August 15, 2013

RFB NO. 313072- ADDENDUM NO. 4

ALLIANT ENERGY CENTER PAVILIONS

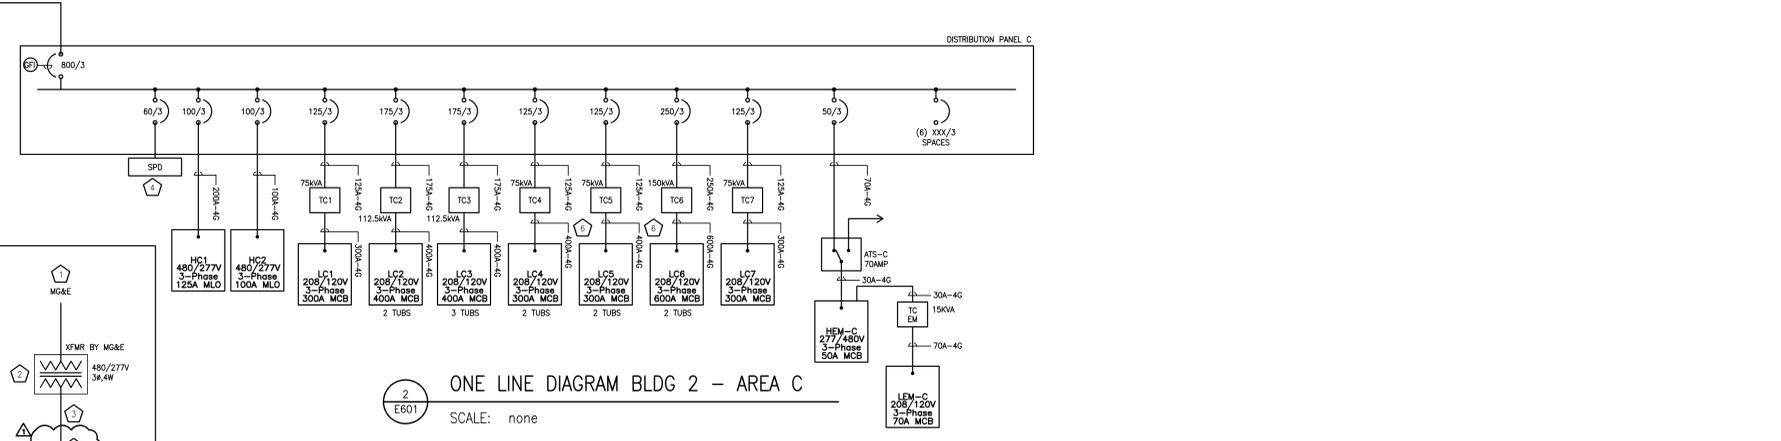
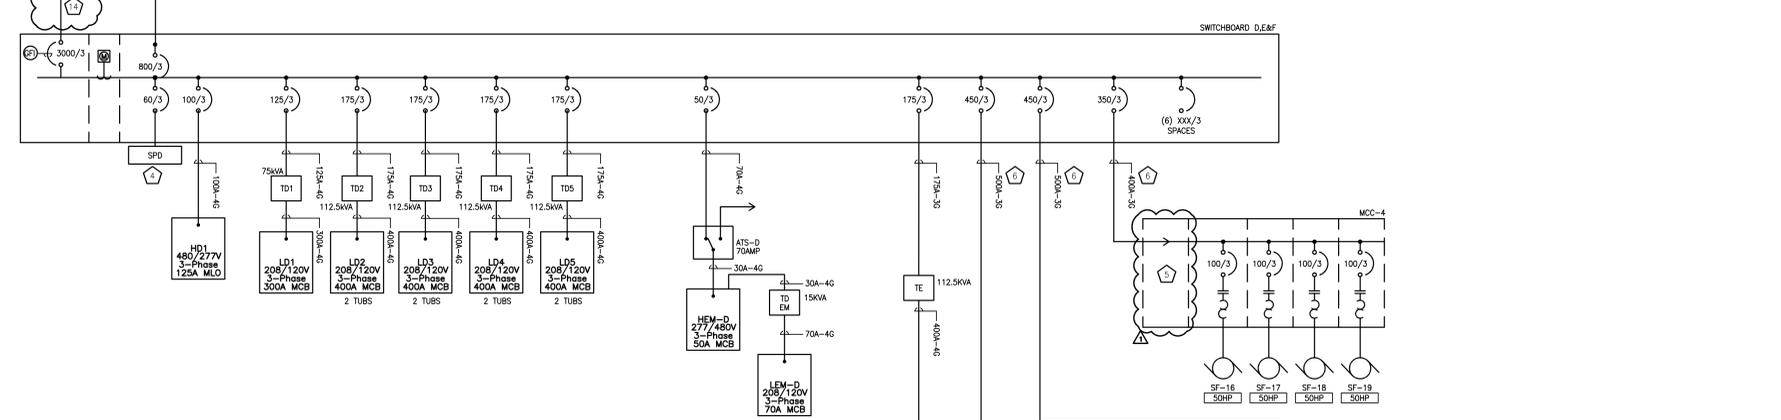
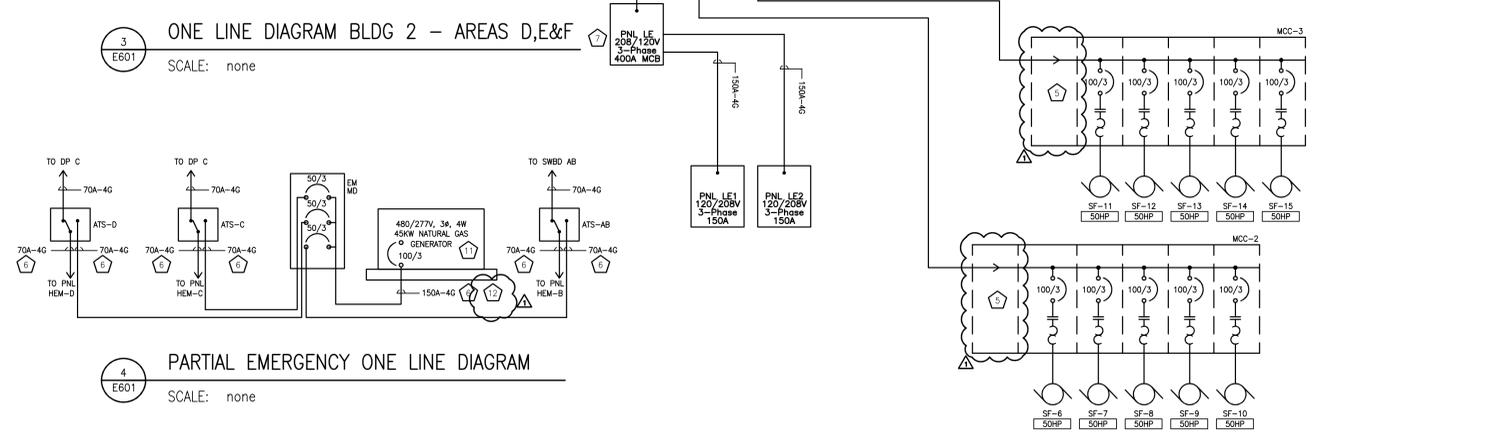
- A. Room 115, Mechanical Room, feeder shown connected to panel HA1 is not correct. Feeder is actually connected to Switchboard A&B as shown on One Line Diagram on Sheet E601.
- B. Add circuit 40 from Panel LA1 to every other receptacle in Office 103.
- C. Add circuit 42 from Panel LA1 to (1) receptacle in Office 105.
- D. Replace Receptacle on column line KK in Rm 117 with (1) 30Amp, 3ph twist-lock receptacle circuit from panel LA1 (67,69,71).
